<input type="checkbox"/> Sidewalk Waiver (Form V2)		
SITE PLANS		<input type="checkbox"/> Waiver to IDO (Form V2)	APPEAL
<input type="checkbox"/> DRB Site Plan (Form P2)	<input type="checkbox"/> Waiver to DPM (Form V2)	<input type="checkbox"/> Decision of DRB (Form A)	
BRIEF DESCRIPTION OF REQUEST			
Amendment to existing preliminary plat and infrastructure list

Re: Durango Unit 3 – Preliminary Plat and Infrastructure List Amendment (PR-2018-001996)

**AMENDED
PRELIMINARY PLAT FOR
DURANGO UNIT 3
UNIT 3 LOTS 1-37 & TRACTS A-C
CITY OF ALBUQUERQUE
BERNILLO COUNTY, NEW MEXICO
PROJECTED SECTION 16, T 11 N., R 2 E, NMPM
TOWN OF ALAMEDA GRANT
JULY 2020**

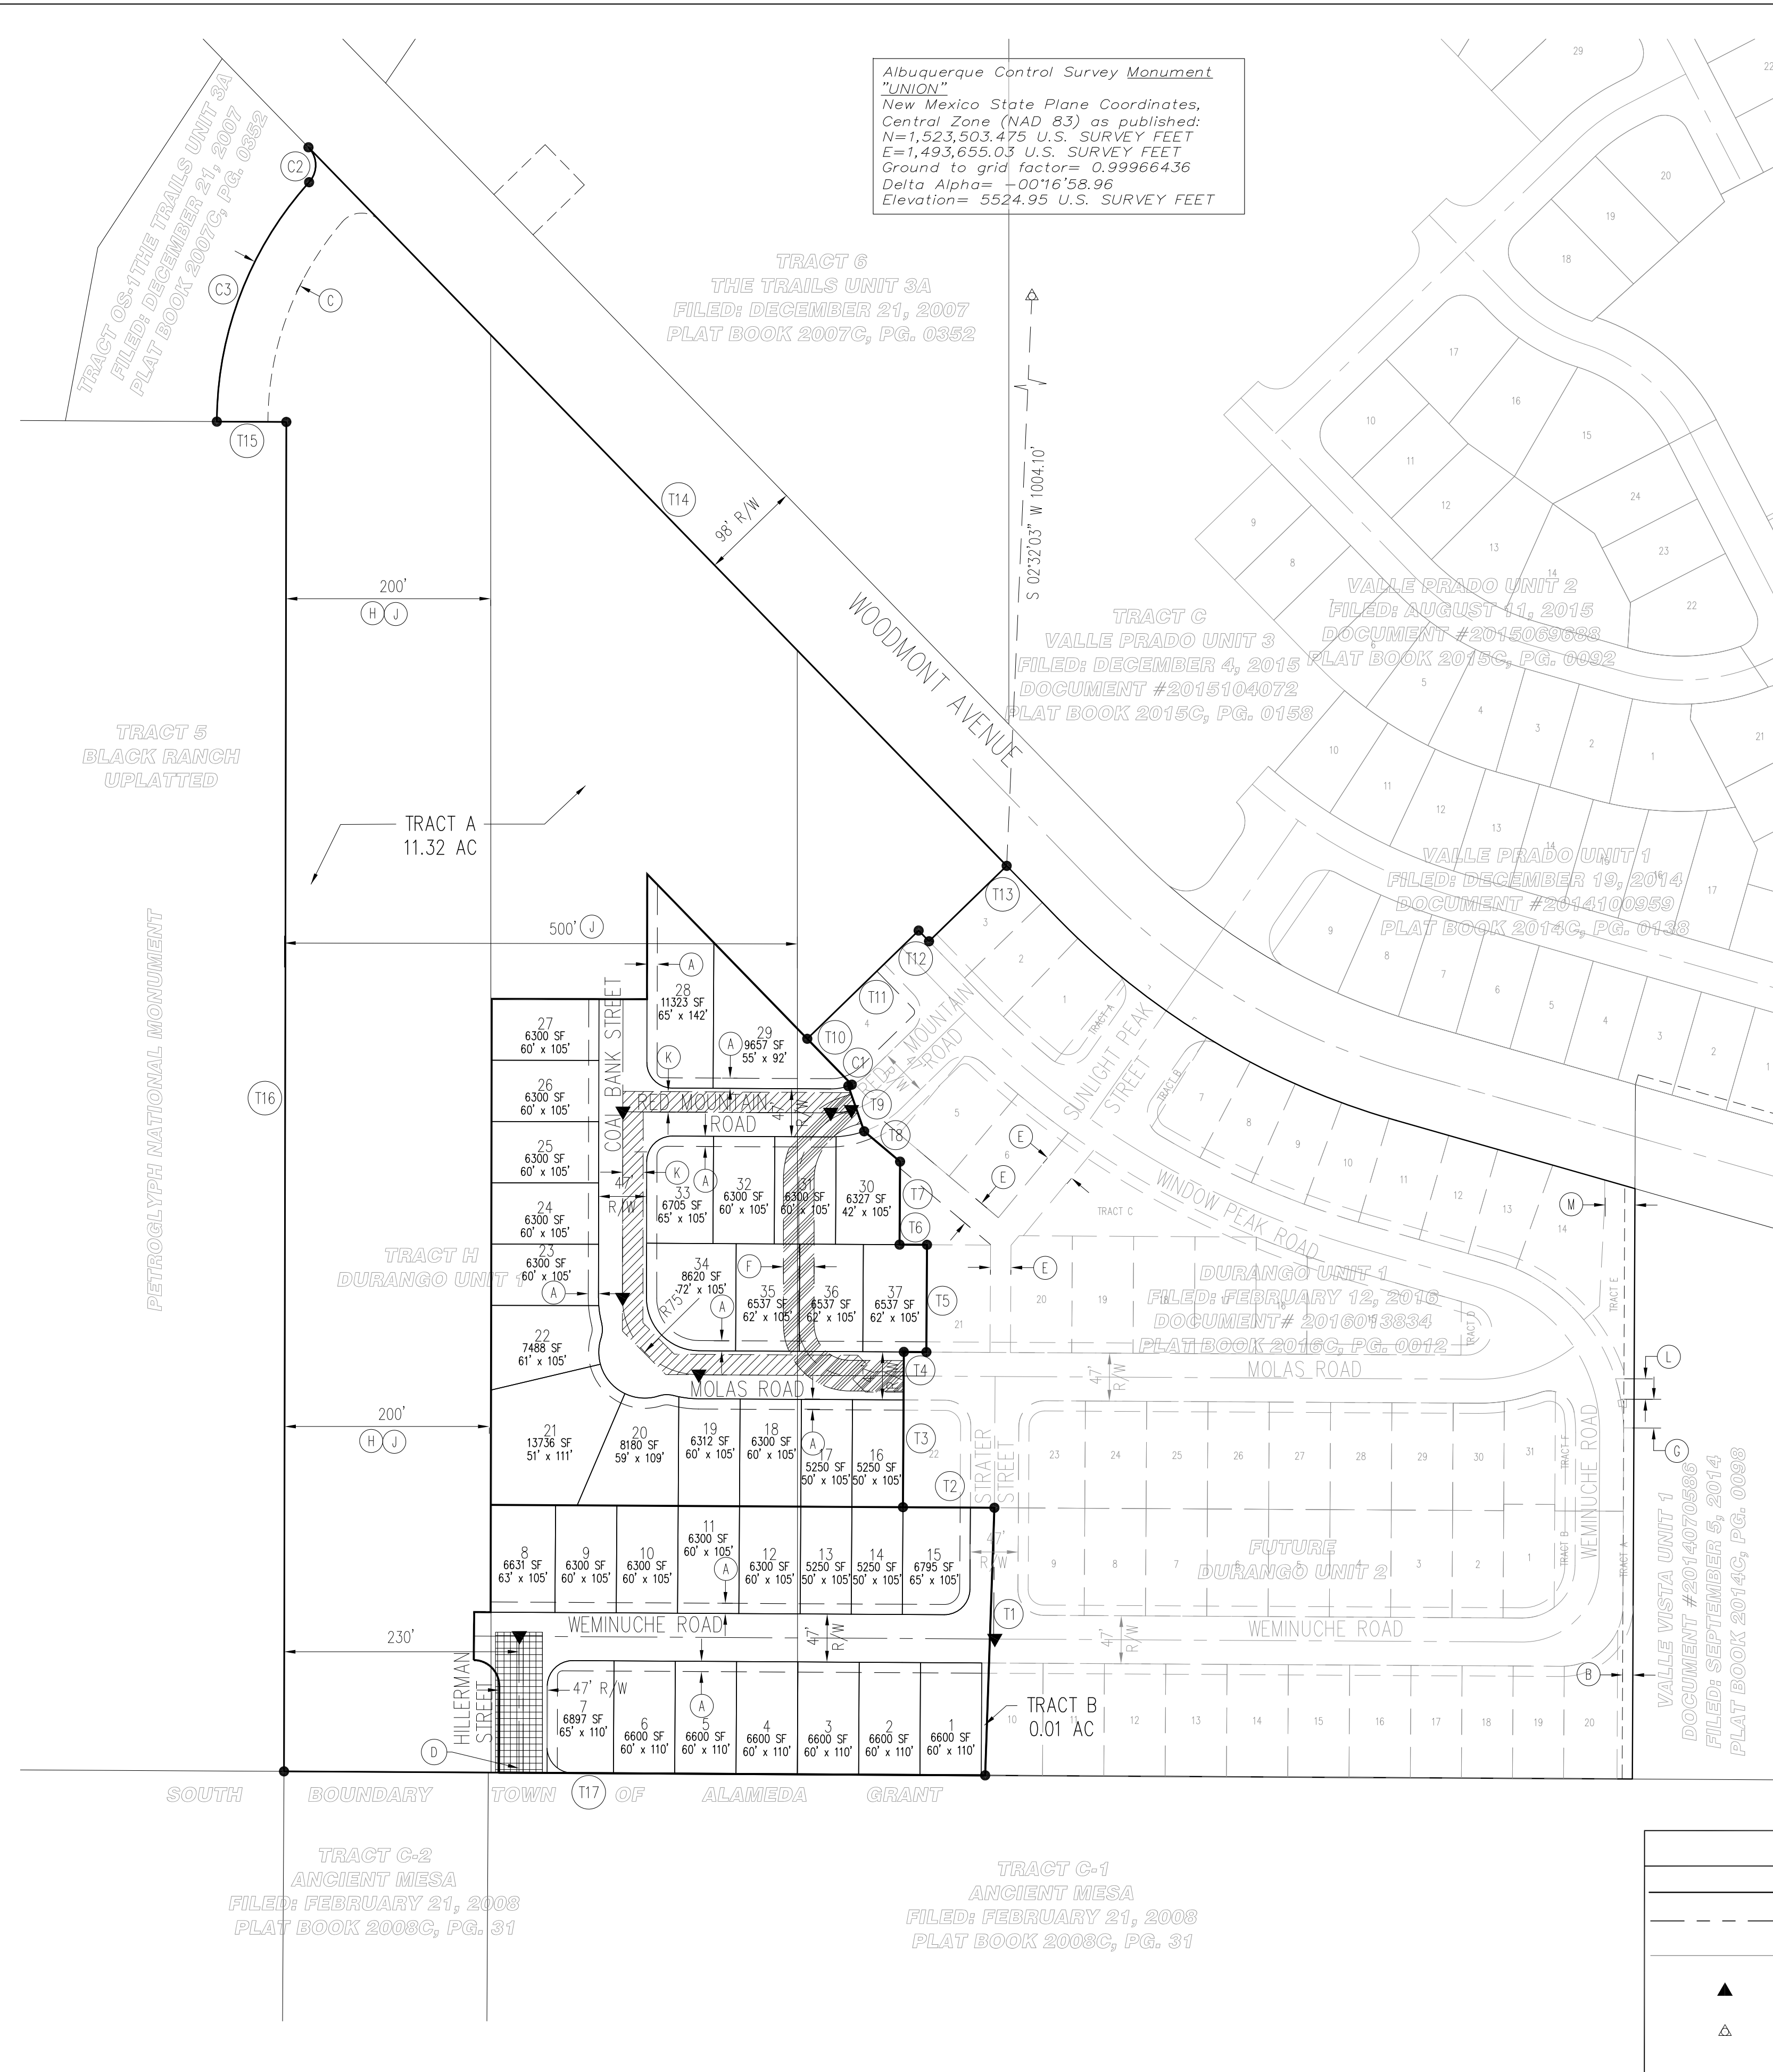
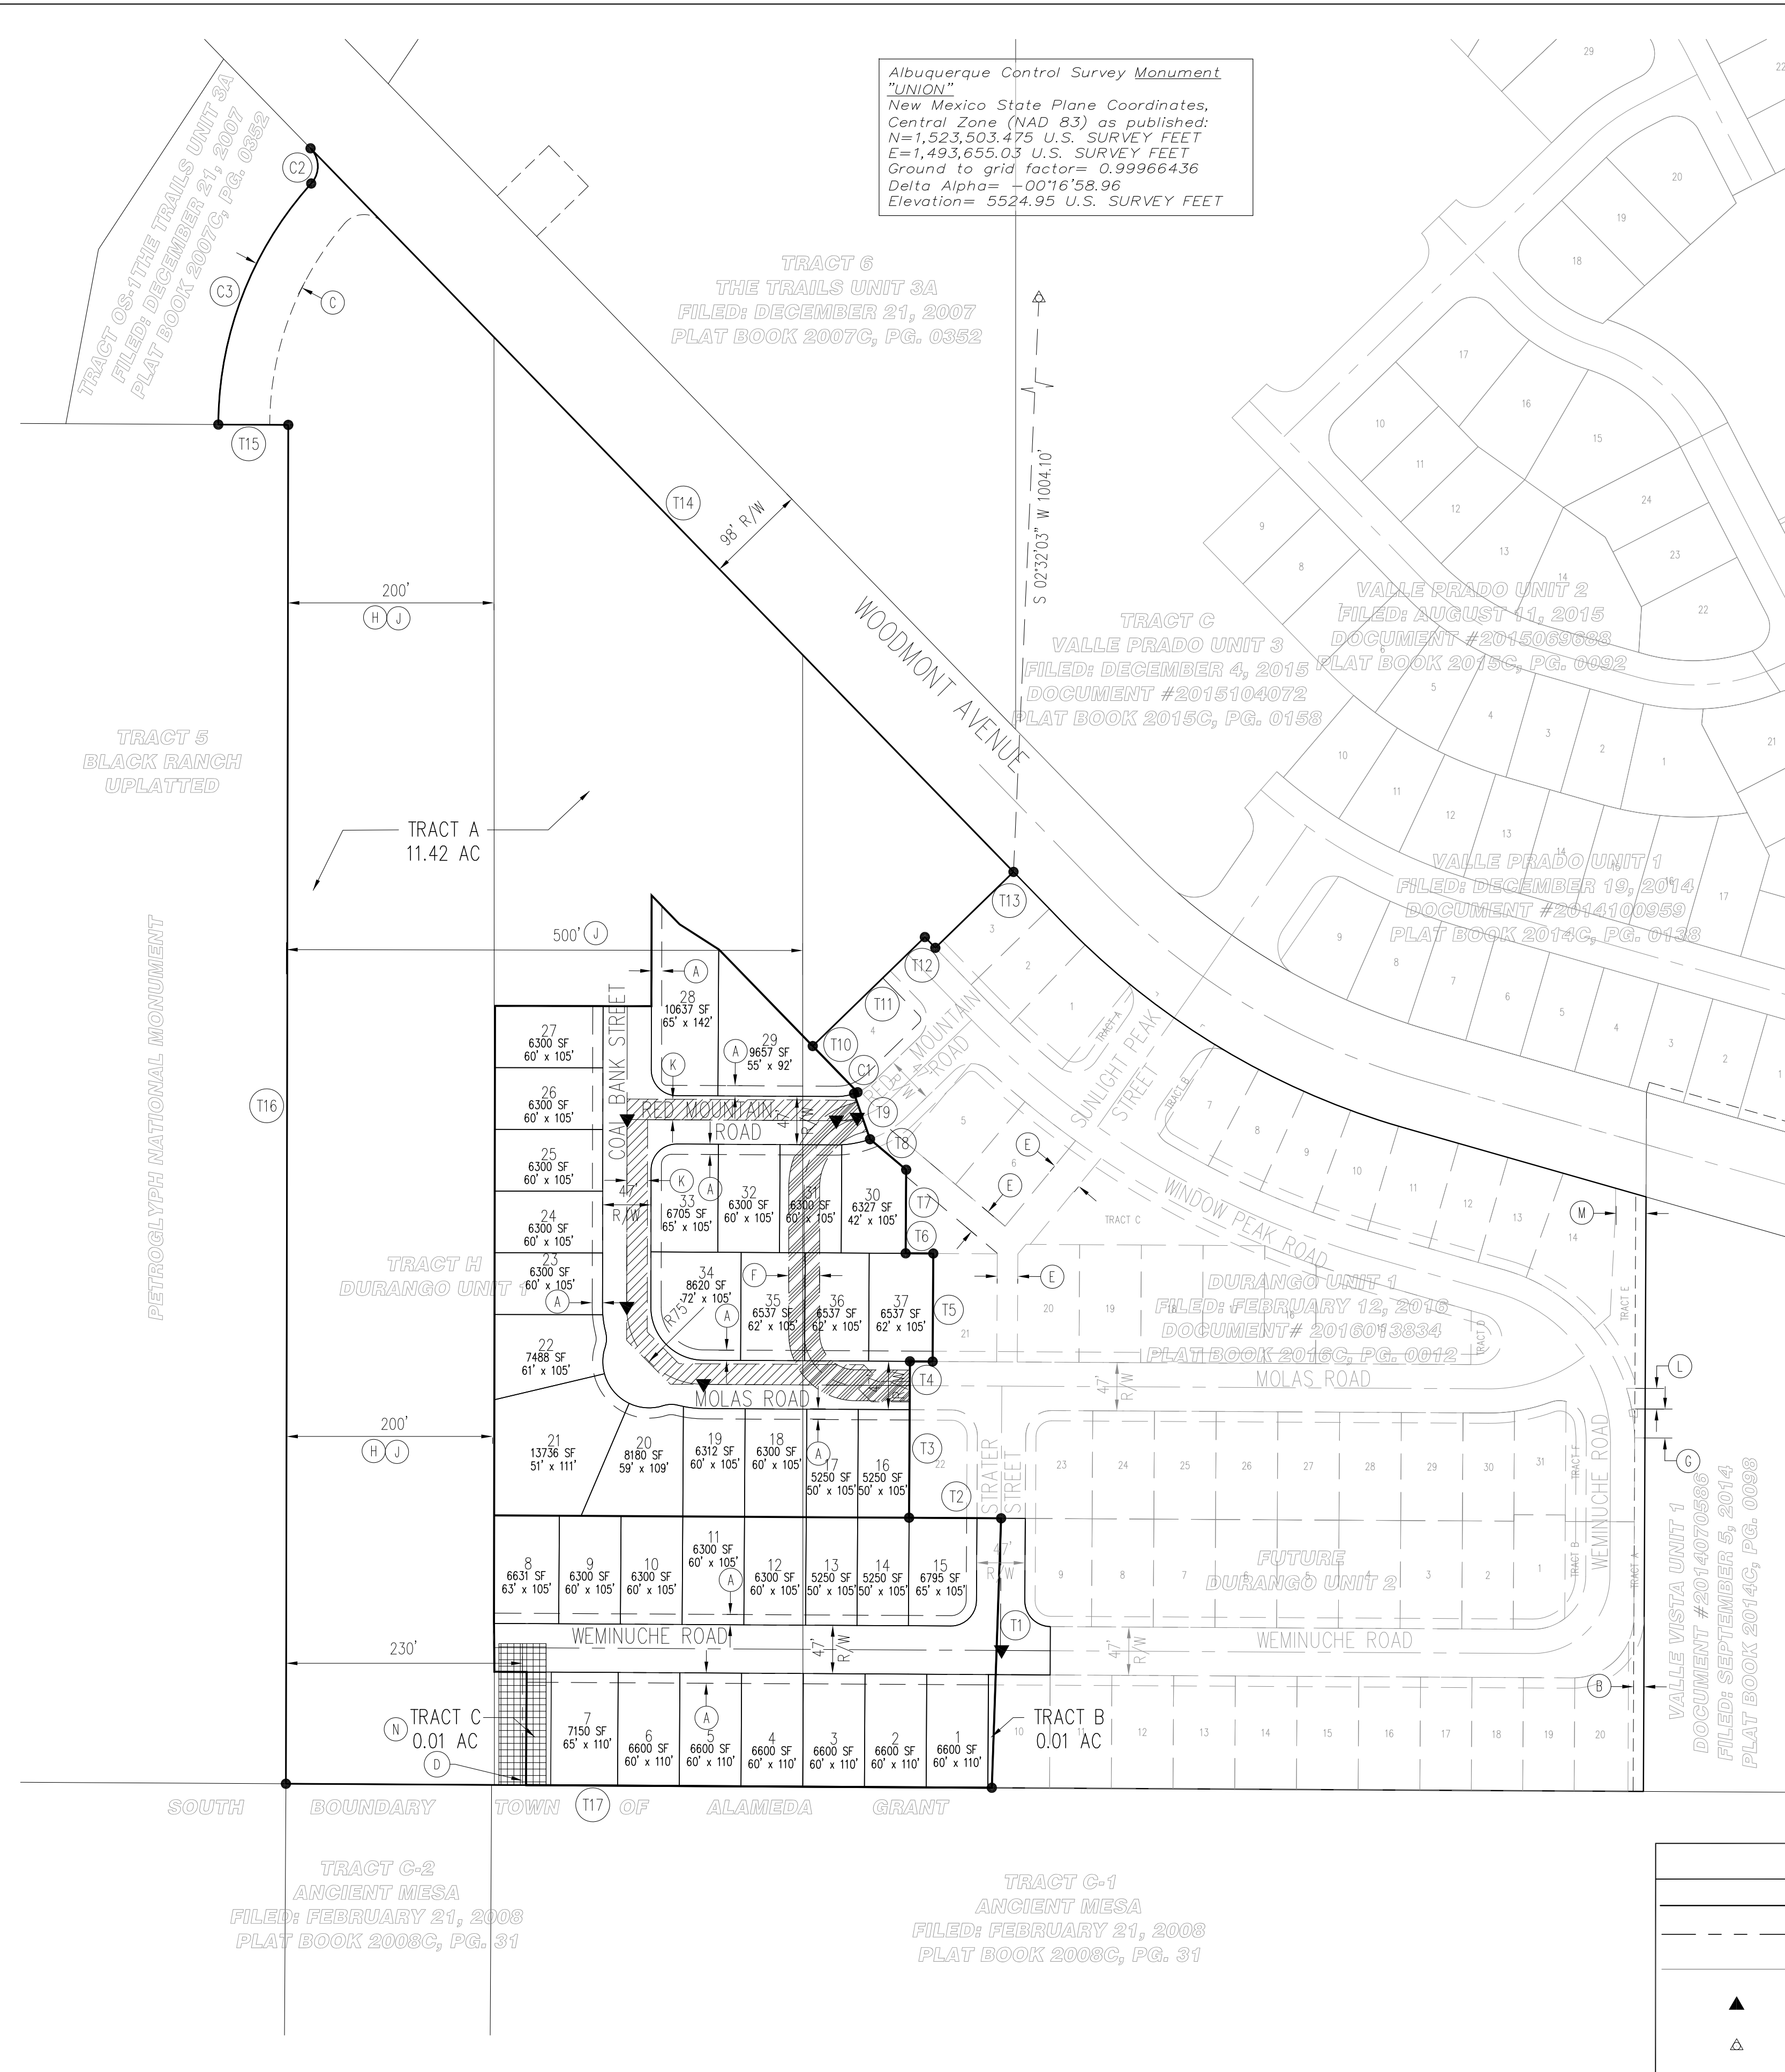
We are requesting an amendment to the existing Durango Unit 3 preliminary plat and infrastructure list to remove the Hillerman Street connection from Weminuche Road to the Tierra Antigua Elementary School site. The preliminary plat and infrastructure list were approved by the DRB on August 14, 2019.

We are requesting the removal of Hillerman Street because Albuquerque Public Schools (APS) does not intend to allow vehicular access from the Durango Subdivision to the school site. APS is in favor of allowing a pedestrian connection to the site. Therefore, the Hillerman Street right-of-way has been replaced by a private open space tract that will be owned and maintained by the Trails Community Association, Inc. The tract will have a blanket public pedestrian access easement. A sidewalk will be constructed on the tract from Weminuche Road to the Durango south boundary. A pedestrian access gate will be installed on the property line to allow APS to control access to the school.

- BLANKET PUBLIC PEDESTRIAN ACCESS EASEMENT GRANTED BY PLAT.
